PRODUCT/PROCESS CHANGE NOTICE (PCN)

PCN #: MM1809-01 Date: September 26, 2018		MEANS OF DISTINGUISHING CHANGED DEVICES:	
Product Affected: 9FGV1006AnnnLTGI (8) 9FGV1006Q5nnLTGI (8) (Refer Attachment II for the affected part#)		☒ Product Mark Change in the top mark and orderable part#	
Date Effective: December 26, 2018		☐ Back Mark	
		☐ Date Code	
		☐ Other	
Contact: Victor Abarca		Attachment: ☒ Yes ☐ No	
E-mail: victor.abarca@idt.com		Samples: Samples are available now.

ATTACHMENT I - PCN # : MM1809-01

Figure 1 9FGV1006A/9FGV1006Q5 Spread Off to Spread On Transition

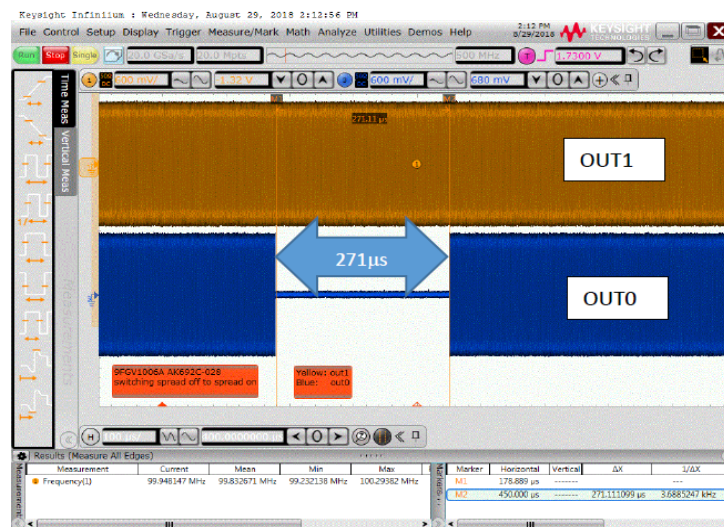
This notice is to advise our customers that a quality improvement was made to the part numbers as listed in Attachment I to resolve the issue of OUT0 to stop for approximately 200 to 270uSec when turning Spread on or Spread off.
